**Memo To:** Giuliano La Moglie, Senior Planner – Development

**Subject:** Official Plan Amendment and Zoning By-Law Amendment

**Municipal Address:** 40, 50, 60, and 74 Stouffville Road

**City File No.:** OPA-24-0002 and ZBLA-24-0003

## **Appendix**

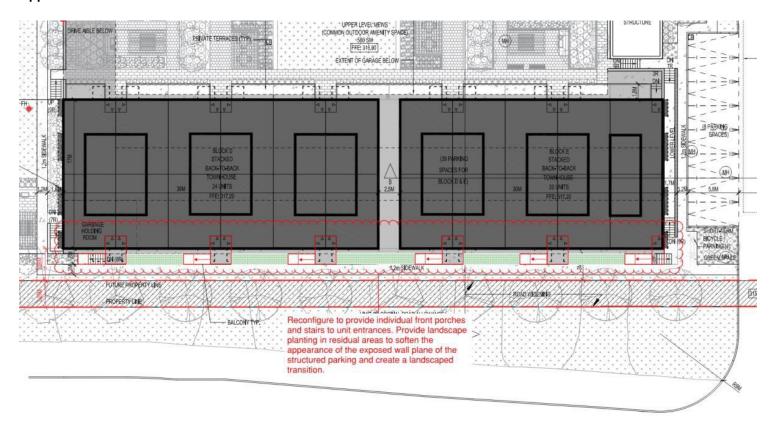
3. Elevated Walkways	The elevated walkway along the south elevation of Blocks D and E may detract from the public realm and overall presentation of the development. The applicant should consider reconfiguring this to smaller front porches with individual stairs, dedicated to each grouping of unit entrances. Moreover, provide landscape planting within the residual areas to soften the exterior wall of the structured parking. See annotated Site Plan appended below.	OP 3.4.1.30, UDGs 6.4.15, 6.4.16

Reconfigure the elevated walkway to individual porches and stairs to unit entrances; provide landscape planting in residual areas to soften the exposed wall of structured parking and foster a landscaped transition to private spaces.
